**RESPONSES OF WINDHAM SOLAR, LLC
TO
CONNECTICUT SITING COUNCIL INTERROGATORIES - SET ONE**

On December 30th, 2020, the Connecticut Siting Council (“Council”) issued Interrogatories, Set One to Windham Solar, LLC (“Petitioner” or “Windham”), relating to Petition No. 1222A. The Petitioner provides the following responses.

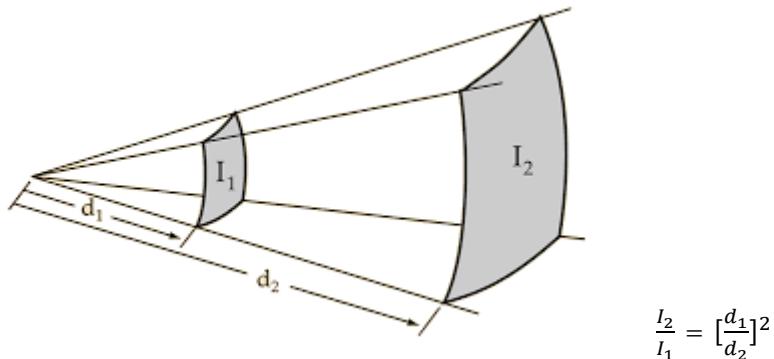
23. Would the proposed Future Projects meet the applicable DEEP noise standards at the property boundaries?

Sec 22a-69-3.5 Requires Class A Receptors to have less than 55dBA at day and 45 dBA at night. Inverters and equipment will be centrally located on the site. String inverters and transformers emit 60dBA at 3 meters from the source. Noise levels change with distance per the inverse square law, see the image and equation below:

Therefore, the reduction of 60dBA at 3 meters (9.8 feet) from the source, to the maximum 55dBA in the daytime is approximately 5 meters (16.4 feet) from the source. All noise emitting equipment on site, is further than (16.4 feet) from the property line. Nighttime audible noise would only be the transformer and ancillary monitoring equipment such as routers, computers and battery backup devices. At 16.8m (55.1feet) from the source in the evening audible noise would be at or below 45dBA. All equipment that would be energized during the evening is also further than 16.8m (55.1 feet) from the property line.

Site Plan

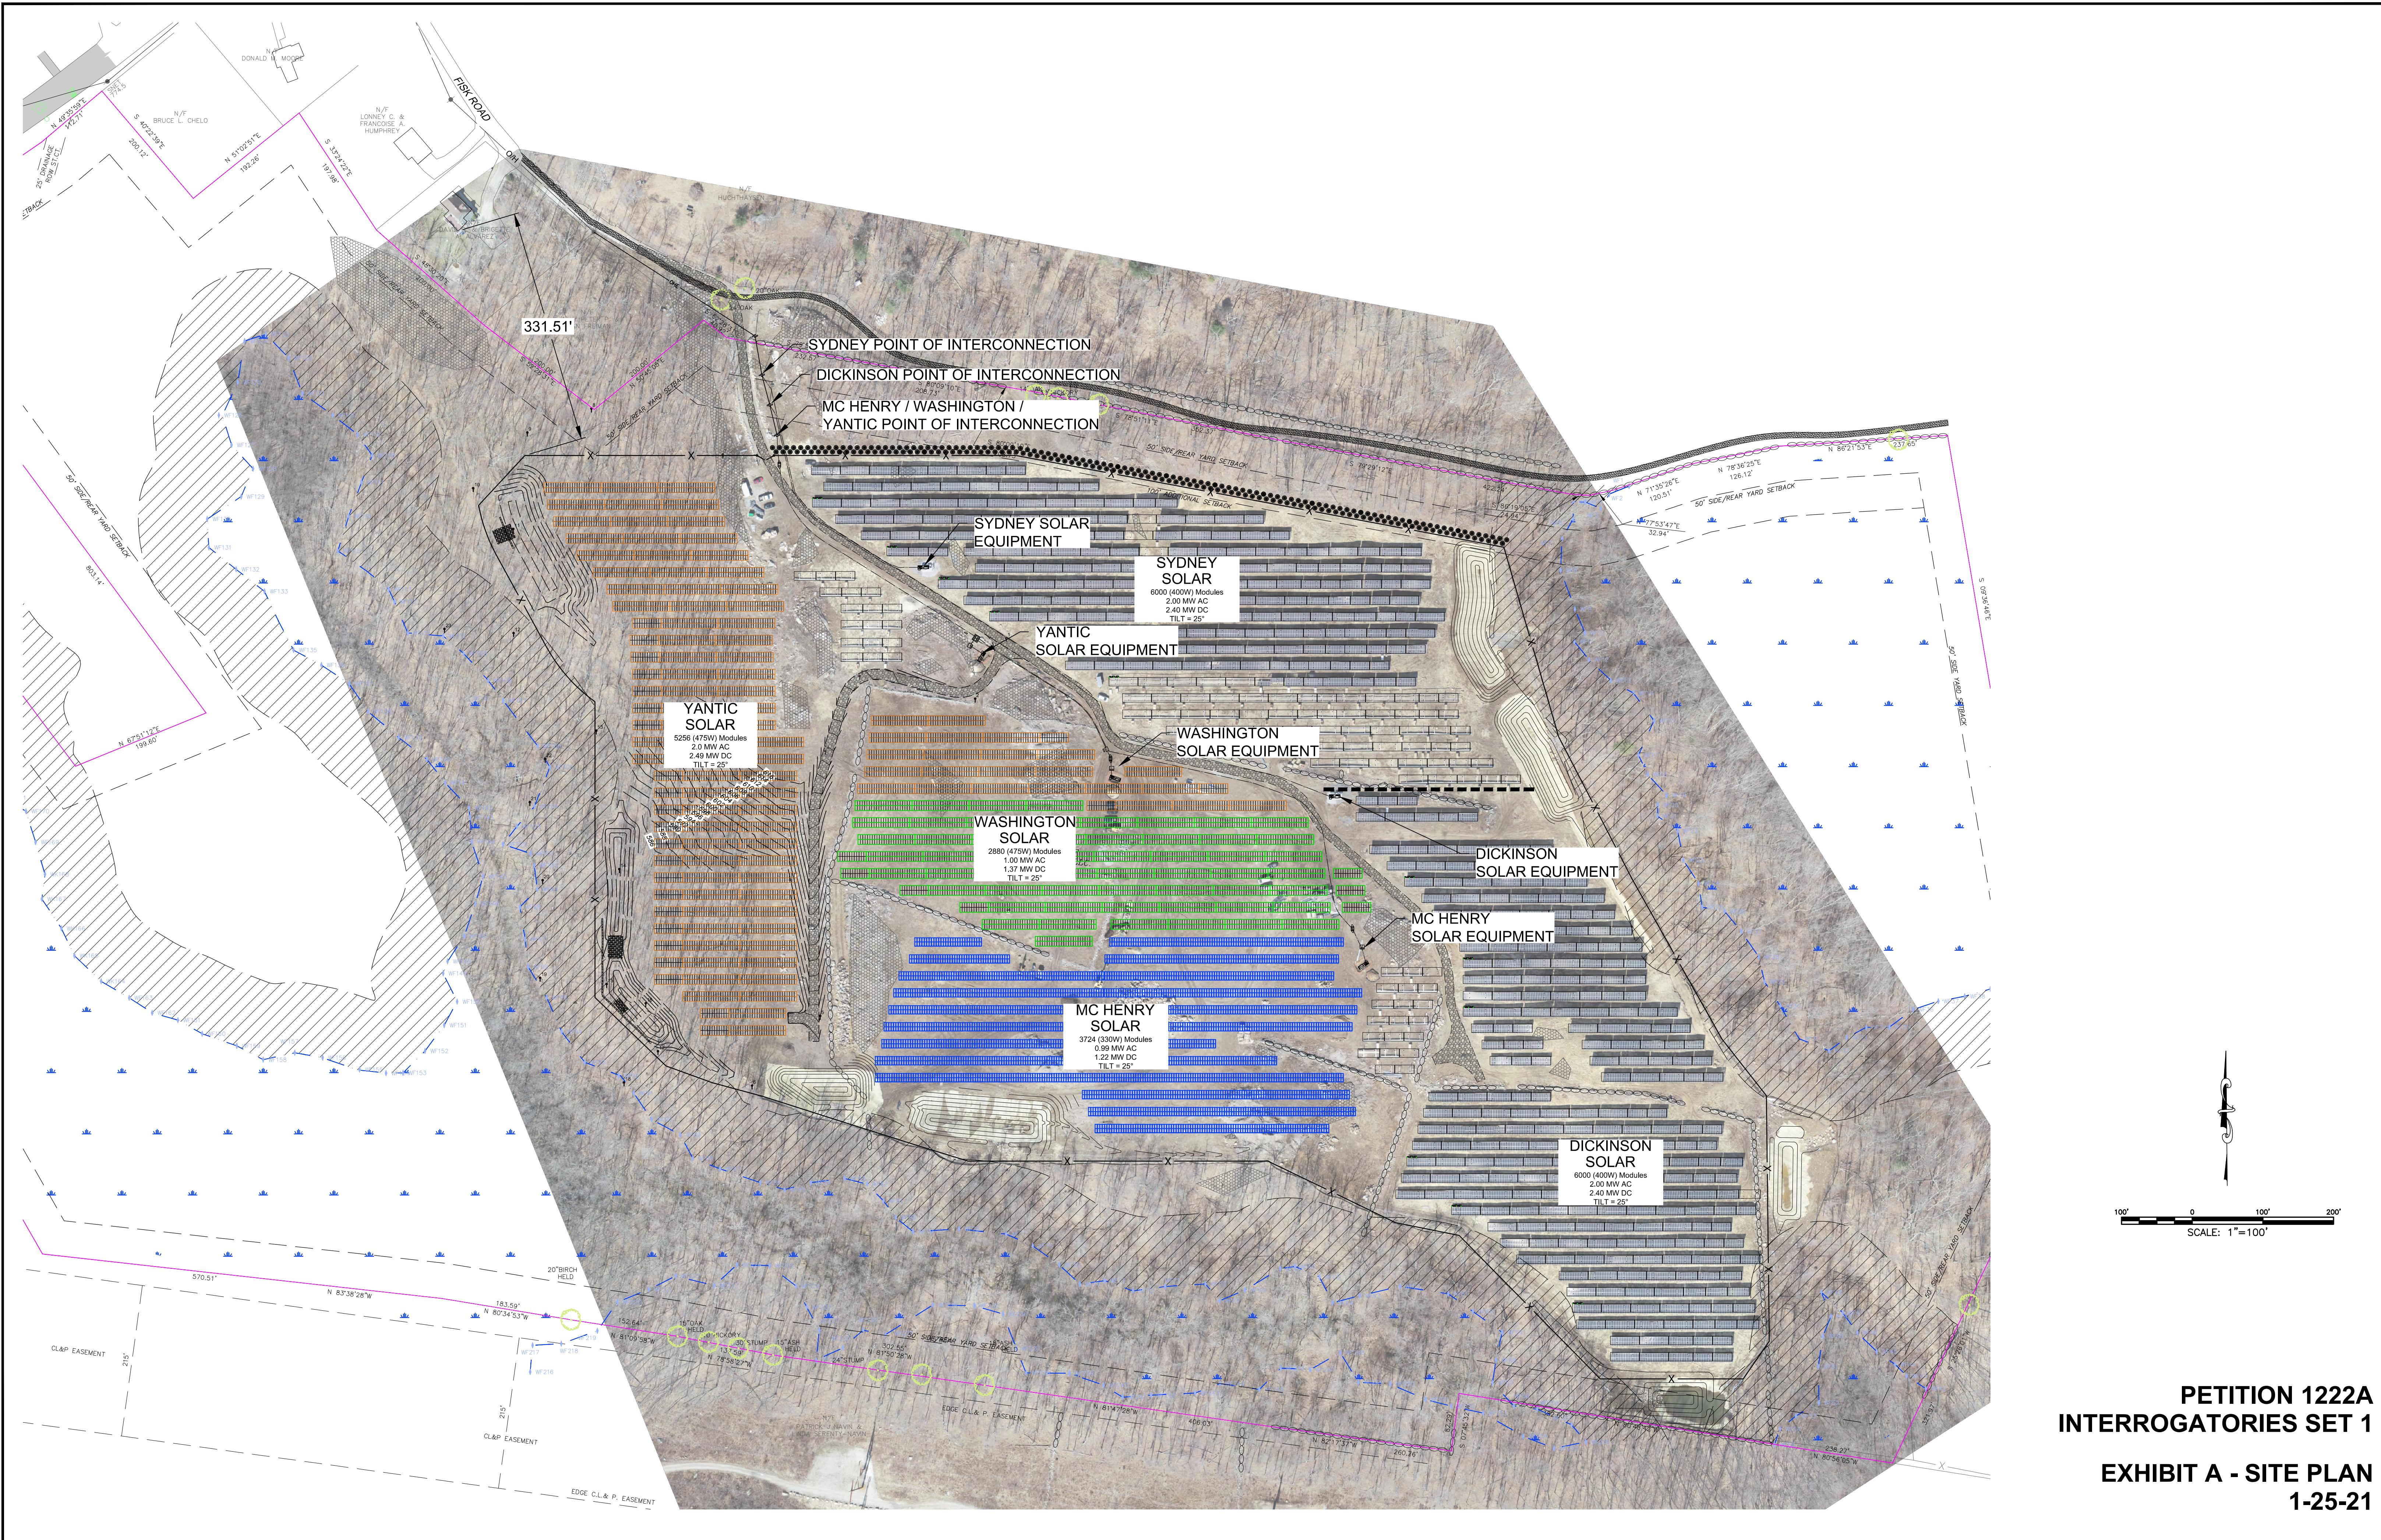
2. Windham Solar, LLC (WS) noted that the Future Projects were denied by the Council. However, attached Sheet No. 4 dated June 15, 2018 indicates three 1 MW AC Future Projects array areas. Please provide a corrected Sheet No. 4 with array labeling consistent with Sheet No. 15 – Landscaping Plan.

A revised overall site plan (***Exhibit A- Site Plan***) has been attached illustrating the currently constructed facilities and the intended solar layouts for the remainder of the site, including the future project area, and the individual project footprints.

Exhibit C
Glare Study

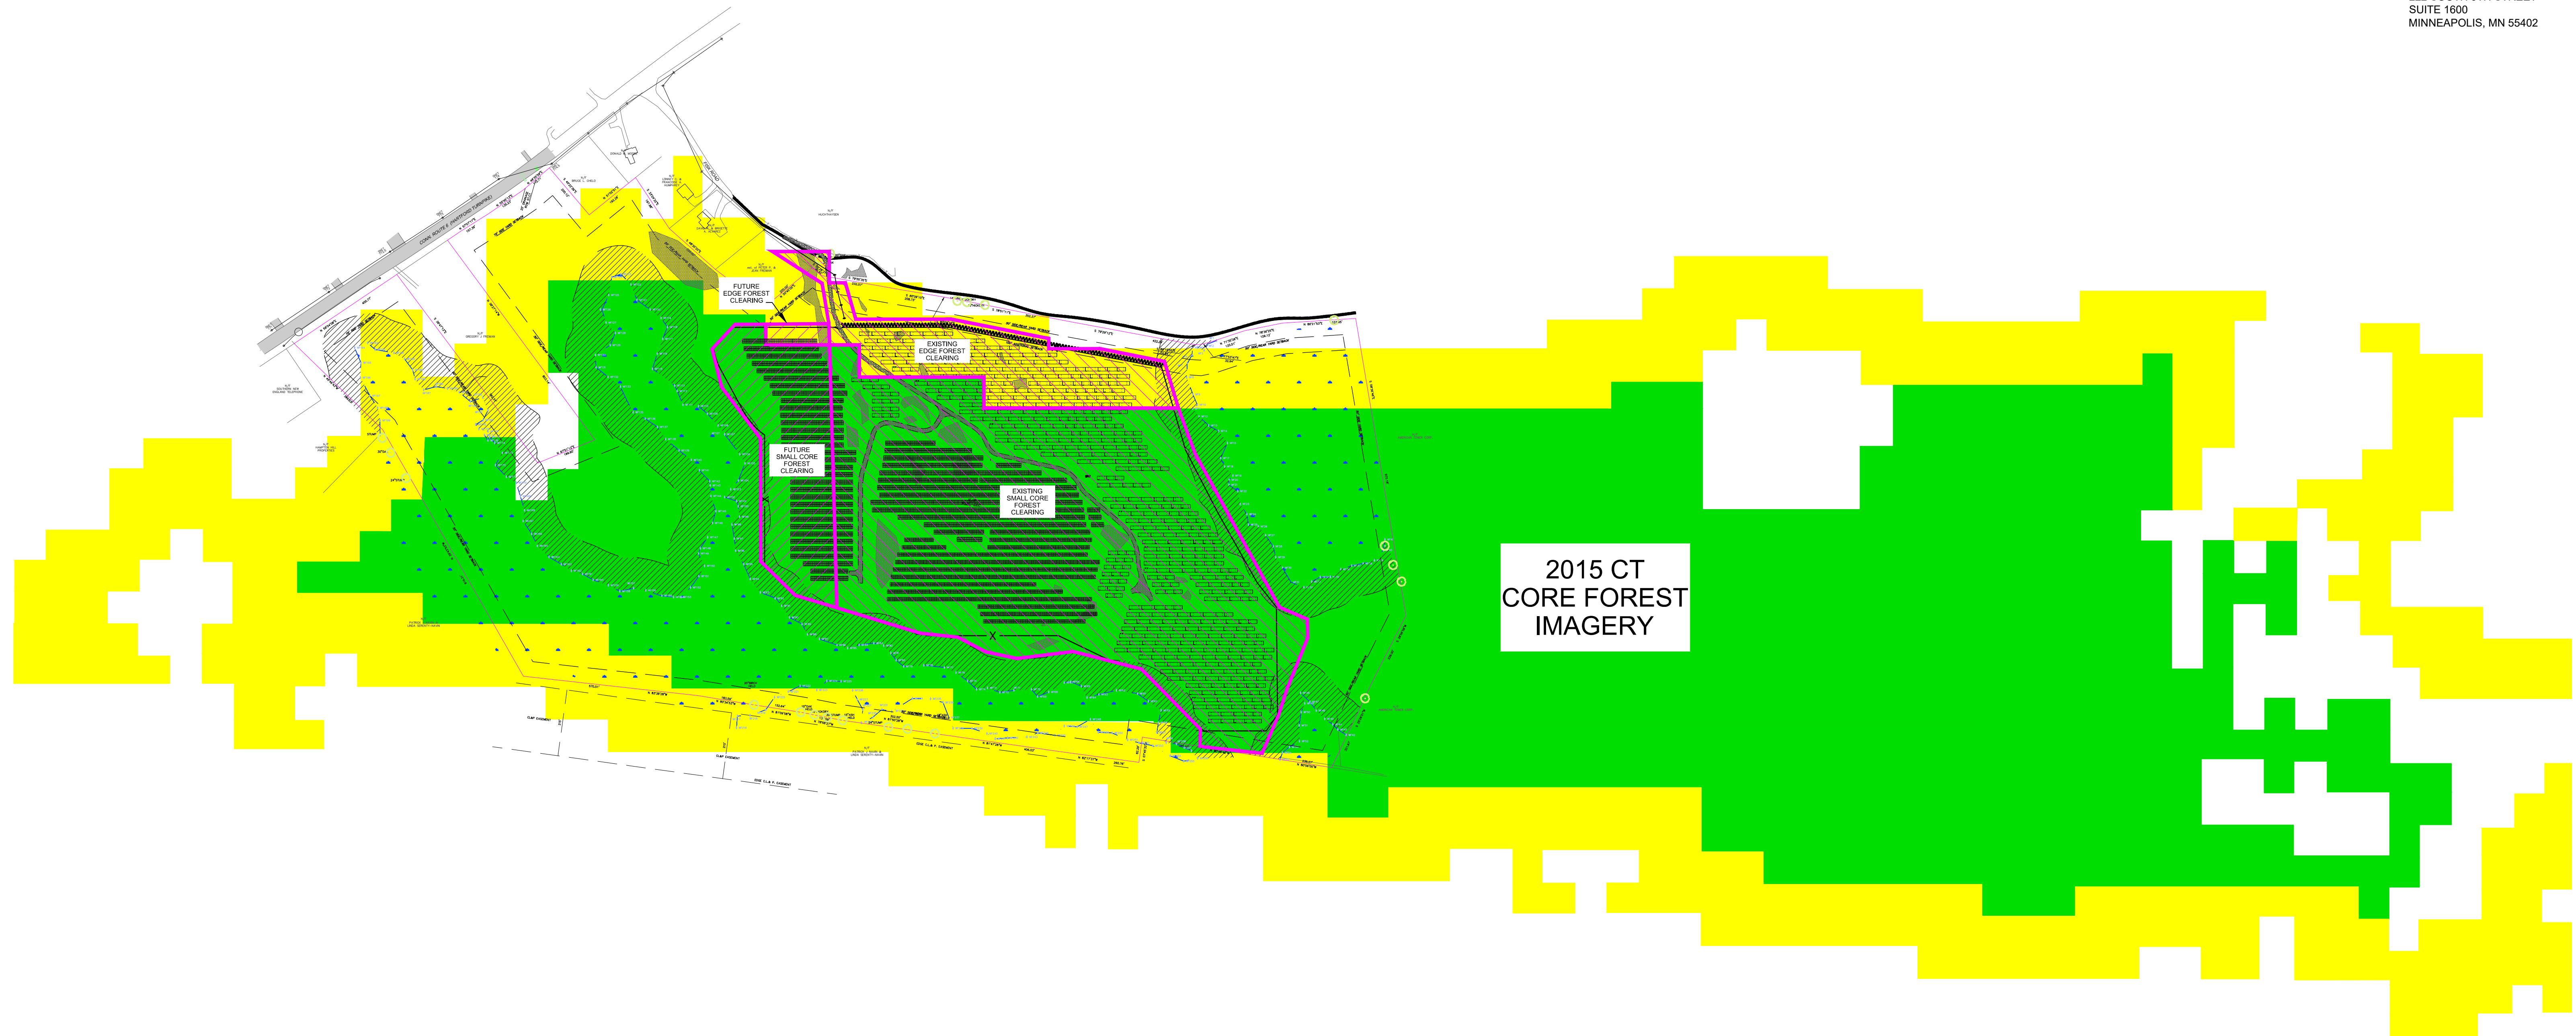
24. Please respond to the comments of the Connecticut Airport Authority dated December 16, 2020.

A glare study was developed in association with the proposed facility expansion (**Exhibit C – Glare Study**). The study utilized a 2-mile flight path from the Windham Airport in the general direction of the proposed facility. The analysis of the flight path as it related to the proposed expansion indicated no glare concerns.

WS believes that there is no safety issue for arriving pilots associated with the existing or future phase facilities.

Vernal Pool Calculations

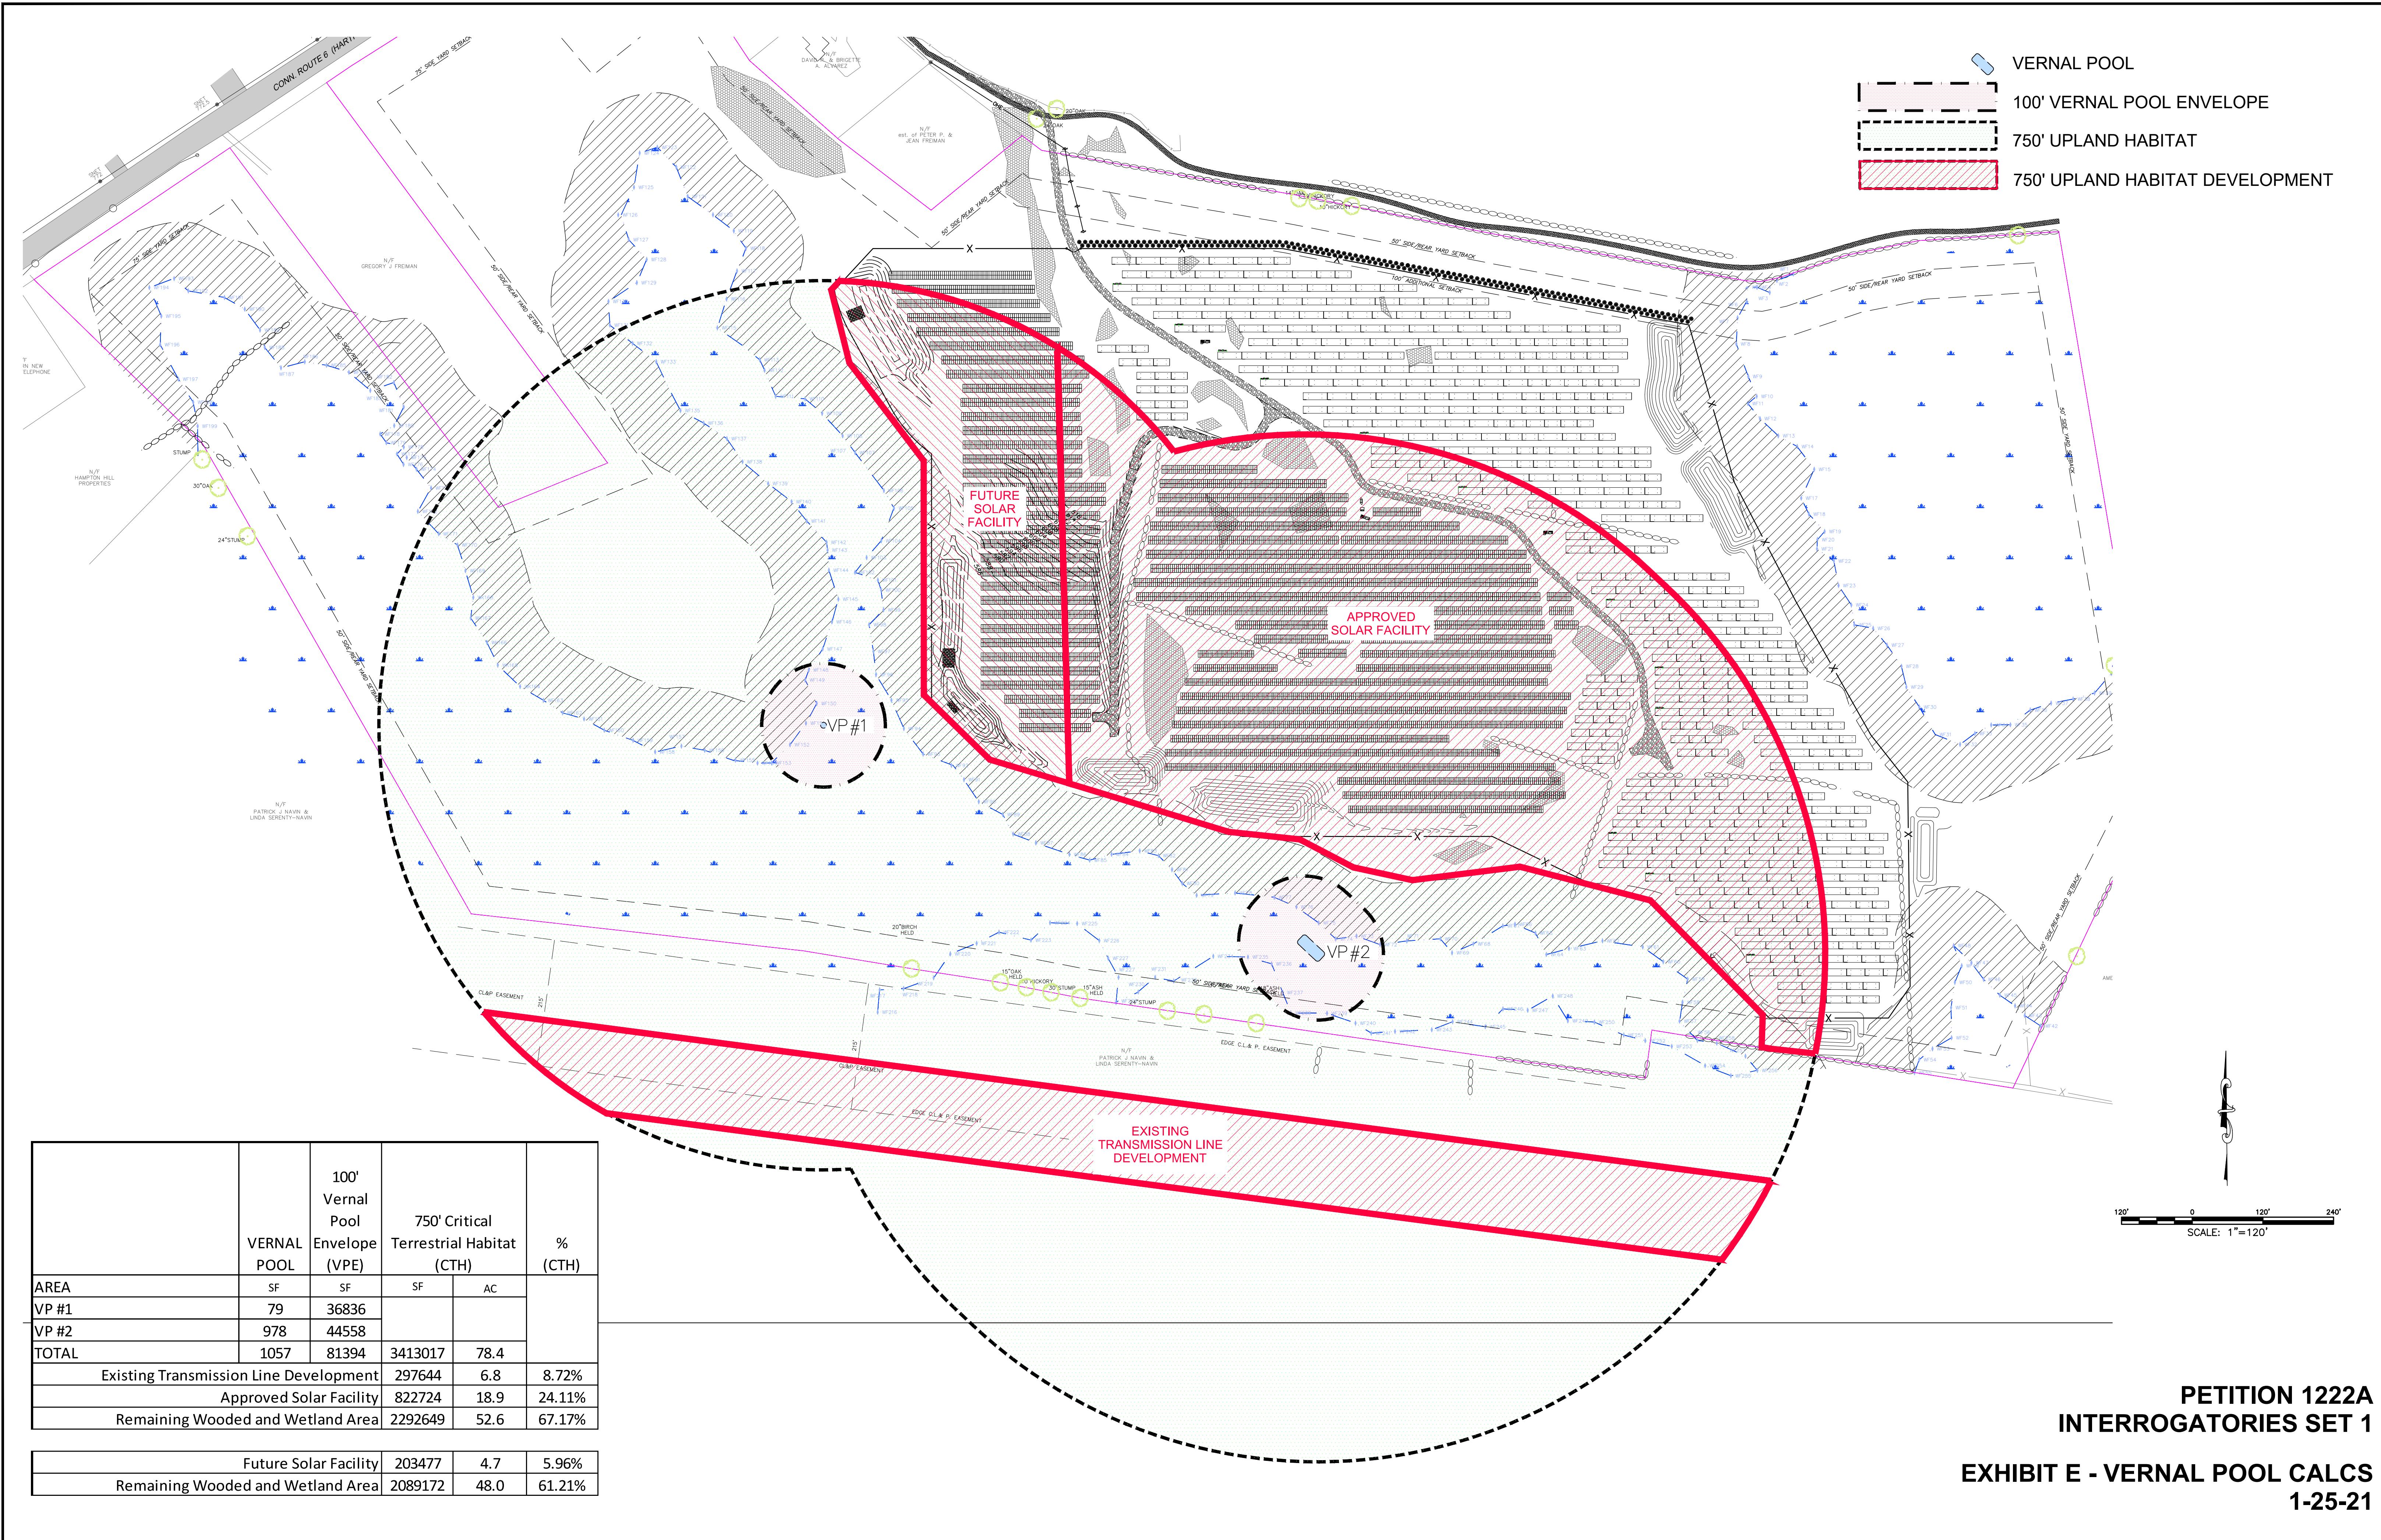
31. Provide the pre-construction and post-construction percent development areas for the 100-foot to 750-foot Critical Terrestrial Habitat Areas for Vernal Pool #1 and Vernal Pool #2 which are identified on Sheet No. 15.

(*Exhibit E – Vernal Pool Calculations*) outlines the Vernal Pool Envelopes and Critical Terrestrial habitat areas associated with Vernal Pools #1 and #2. Impact calculations have been provided for the existing facility, and the additional impacts have been calculated for the future 2MW area.

It should be noted that the reduction of CTH is based on considering solar panel array areas as “developed” land, which is unsuitable for amphibians. However, these areas will not be maintained as a typical lawn, which is excluded by the BDP as suitable habitat. They will be seeded to low, grasses suitable for grazing. Therefore, these areas will not prohibit movement of vernal pool amphibians as they move between habitats or disperse, as would a manicured lawn.
